Service Bulletin

Bulletin No.: 24-NA-022

Subject: SUV Second-Row Bolt Torque Pattern

Brand:	Model:	Model Year:		VIN:		Engine:	Transmission:
		from	to	from	to		
Cadillac	Escalade Escalade ESV	2021	2025	-	-	All	
Chevrolet	Tahoe	2021	2025				
	Suburban						
GMC	Yukon Yukon XL	2021	2025

6535673

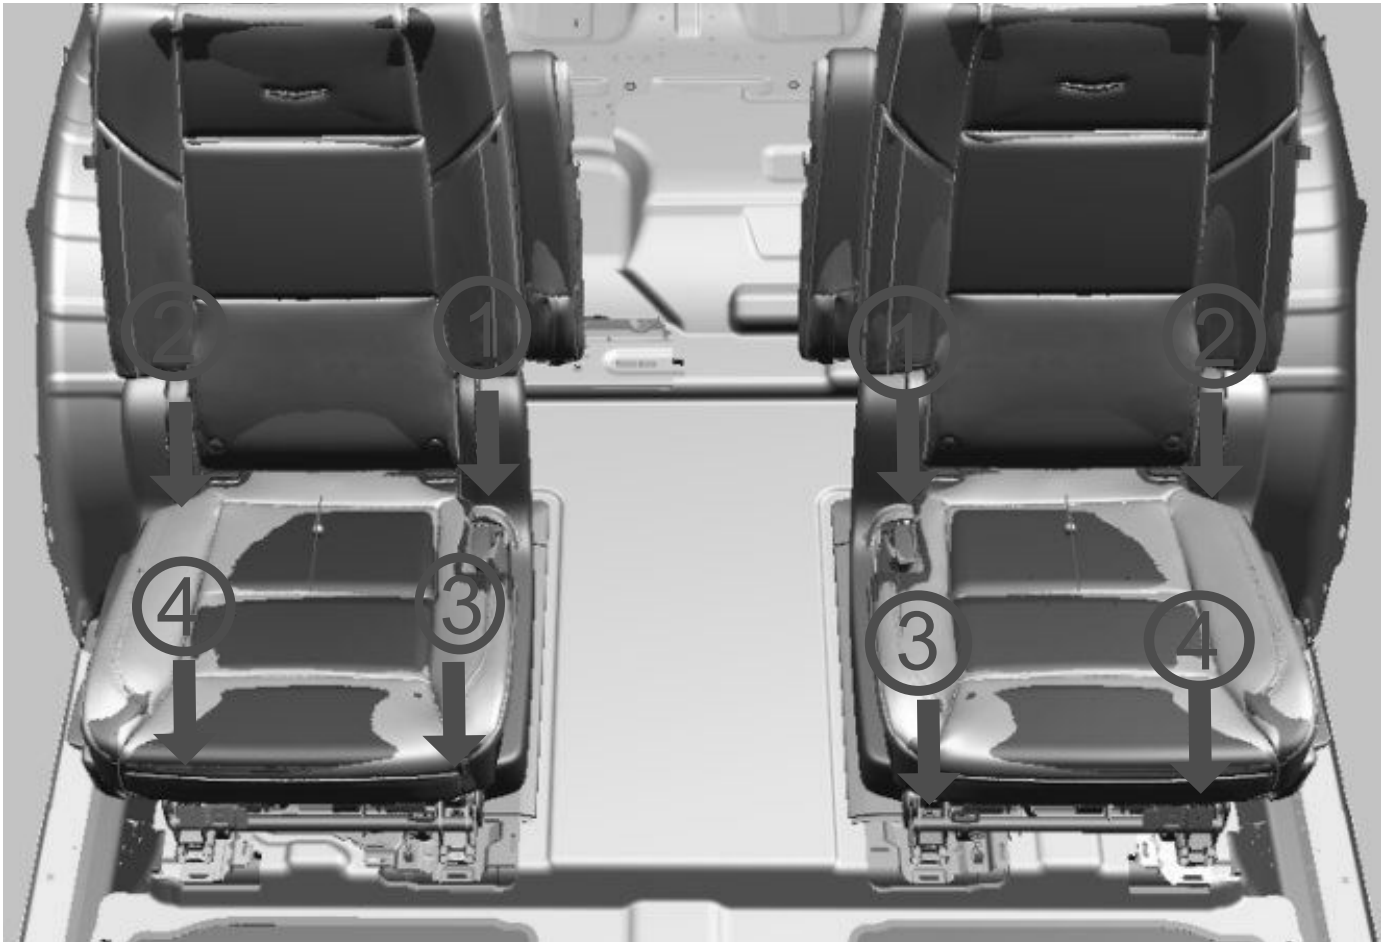
Captains Chairs

1. Refer to document *Rear Seat Removal and Installation* for instruction on how to reuse fasteners or install new ones.
2. Remove the front fasteners.
3. Loosen but DO NOT remove fasteners (1) and (2).
4. Leave fastener (2) loose and retighten inboard fastener (1), refer to the document on how to reuse fasteners.
5. Remove fastener (2).

6. Reinstall all remaining bolts referring to the pattern shown.
7. Refer to the document for instruction on how to reassemble trim

6535676

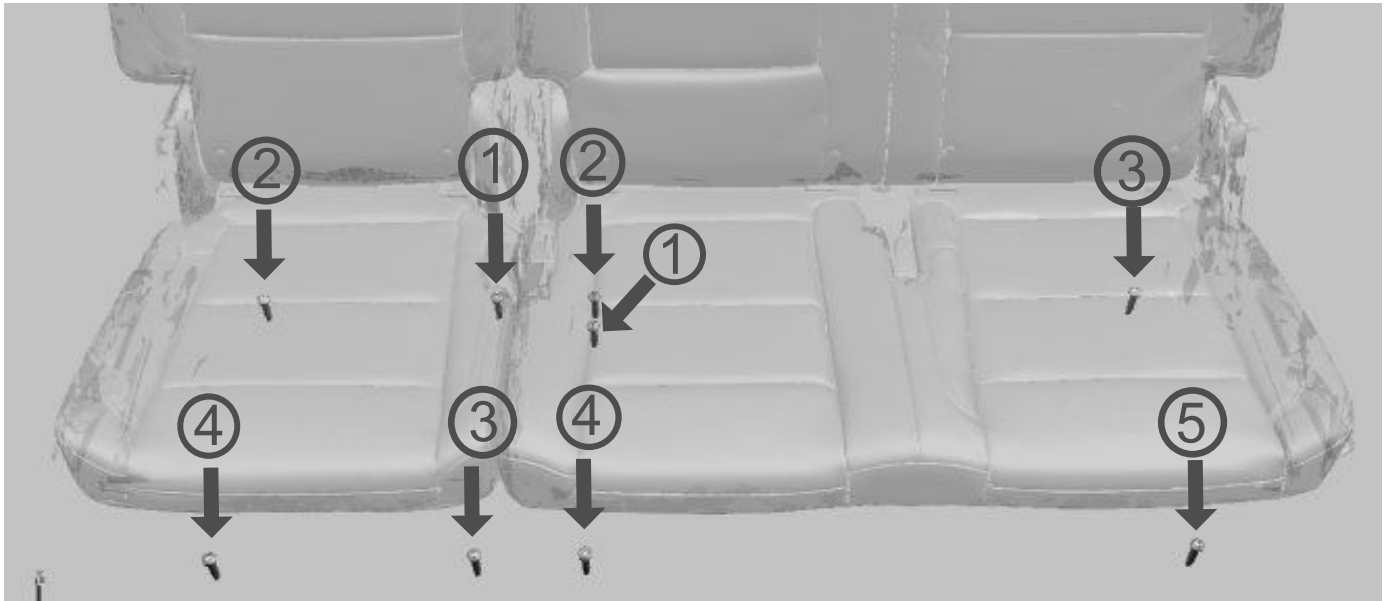
Bench Seats

1. Refer to document *Rear Seat Removal and Installation* for instruction on how to reuse fasteners or install new ones.
2. Remove the front fasteners.
3. Loosen but DO NOT remove fasteners (1), (2), and (3).
4. Leave fastener (3) loose and retighten inboard fastener (1) and (2), refer to the document on how to reuse fasteners.
5. Remove fastener (3).

6. Reinstall all remaining bolts following the pattern shown.
7. Refer to the document for instruction on how to reassemble trim.
